Date: October 30, 2012
File #: 09 - 312701
Folder Name: 606 MARYLAND AVE E
PIN: 292922120095

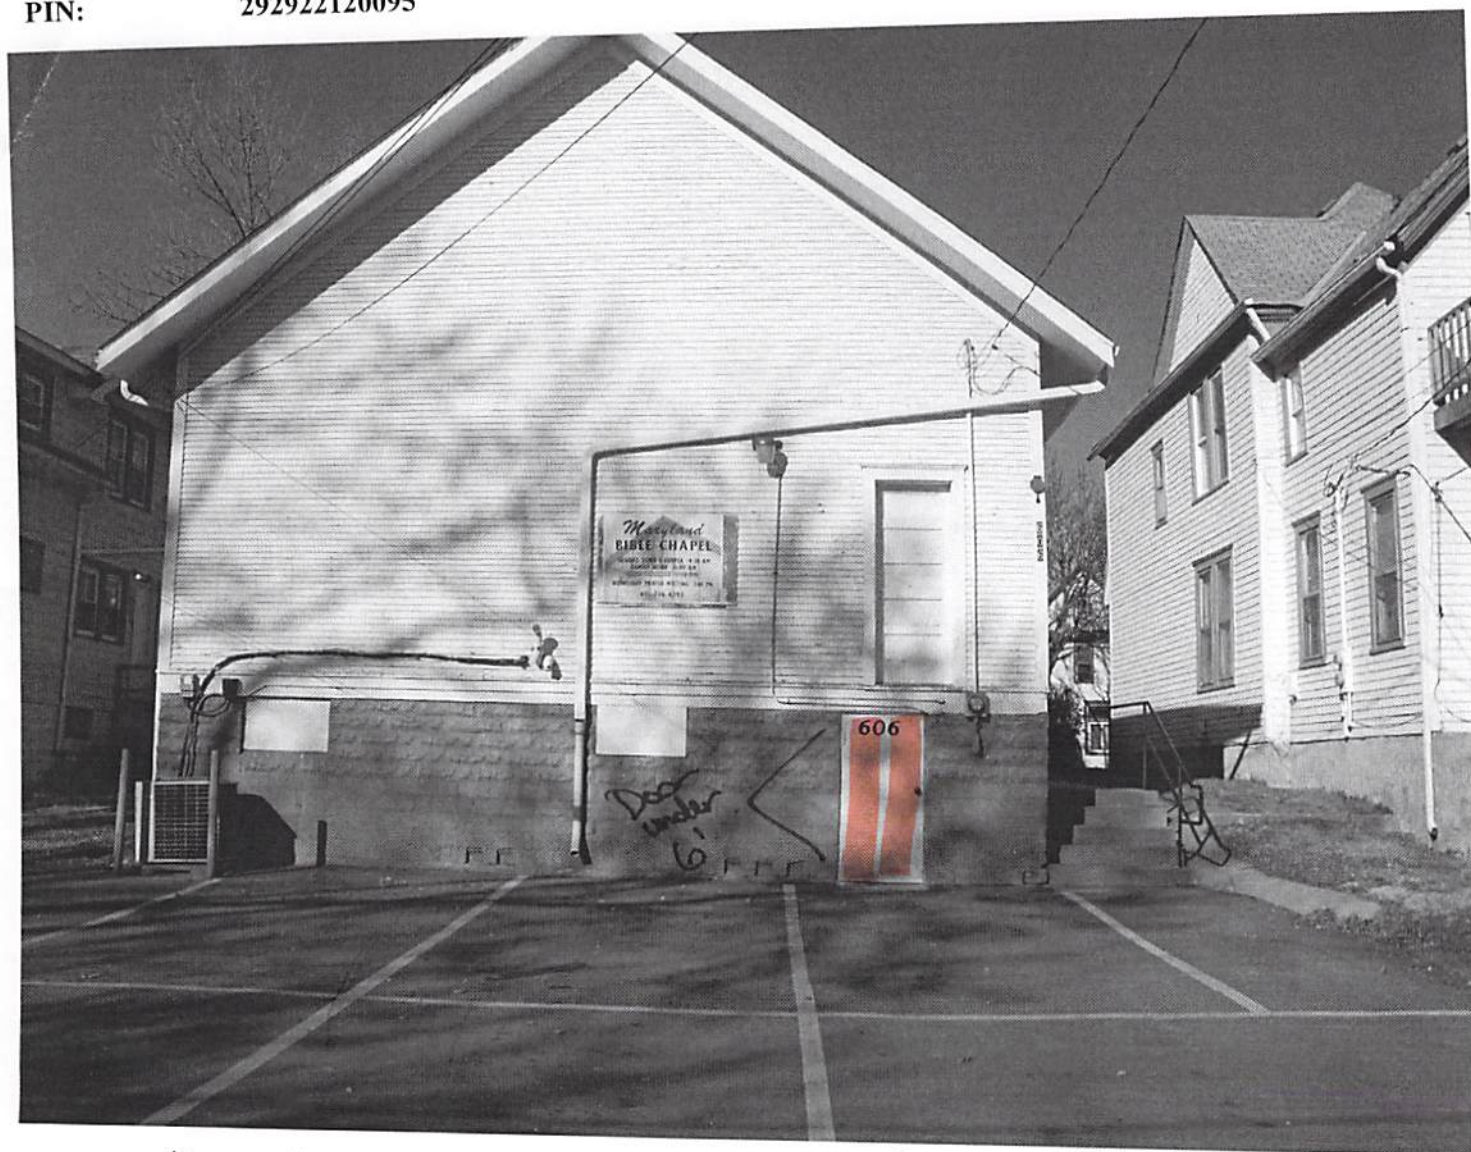
goes through intervening space, (kitchen)
door under 6' - therefore, can't be
counted as a 2nd exit

door under to
open through interior space (interior)
